## REQUEST

Current Zoning: R-3 (single family residential)  
Proposed Zoning: I-1(CD) (light industrial, conditional) and  
MUDD(CD) (mixed use development, conditional)

Approximately 8.39 acres located at the end of Dixie River Road,  
east of Steele Creek Road, south of Interstate 485.  
(Council District 3 - Mayfield)

## PLANNING STAFF REVIEW

### • **Proposed Request Details**

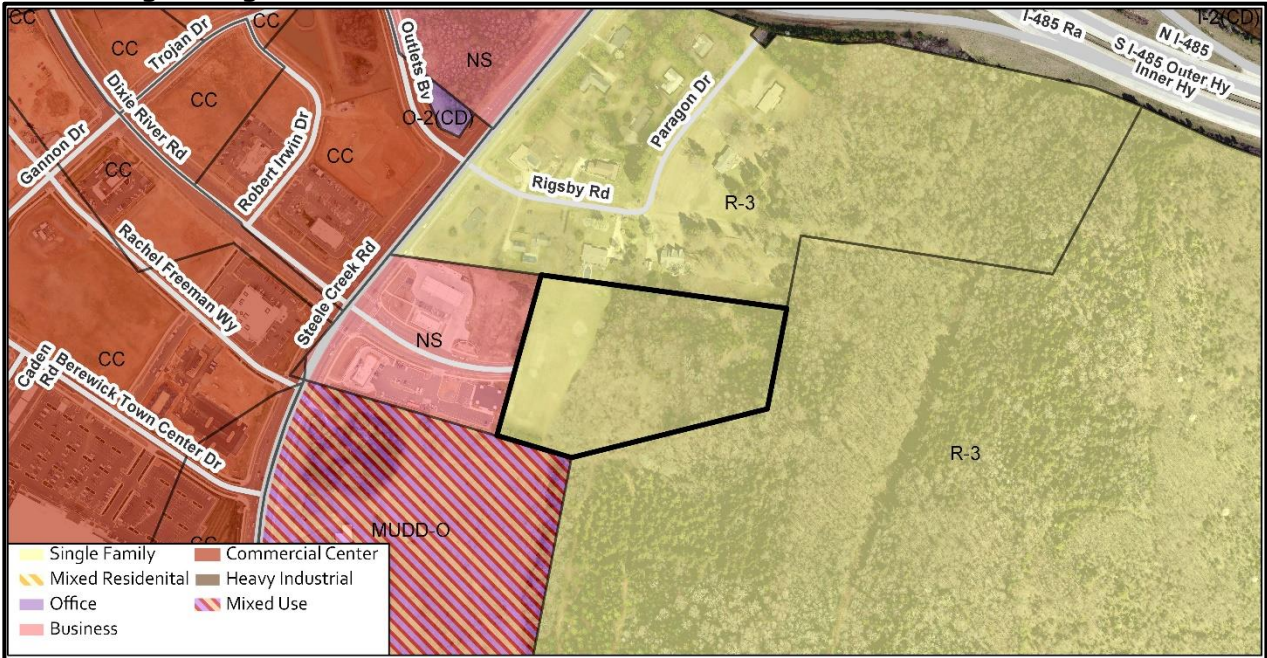
- ## • TRANSPORTATION CONSIDERATIONS
- The site is located on a major thoroughfare. The site plan commits to extending Dixie River Road and a north-south local road creating a road network that meets the intent of the Steele Creek Developer Response and City of Charlotte goals. The roads include the appropriate pedestrian and bicycle facilities.

- ~~See Outstanding Issues, Note 1.~~ Addressed
  - **Vehicle Trip Generation:**
    - Current Zoning:
      - Existing Use: 0 trips per day (based on vacant land).

- ~~1. Update the site plan conditional note(s) to commit to install 25 mile per hour MUTCD signs on the new public streets.~~ Addressed

- ~~2. MUDD areas will be required to provide 15% tree save area onsite. Show tree save area on site map. Tree save area must be 30 feet minimum width. Must contain existing healthy trees.~~ Addressed
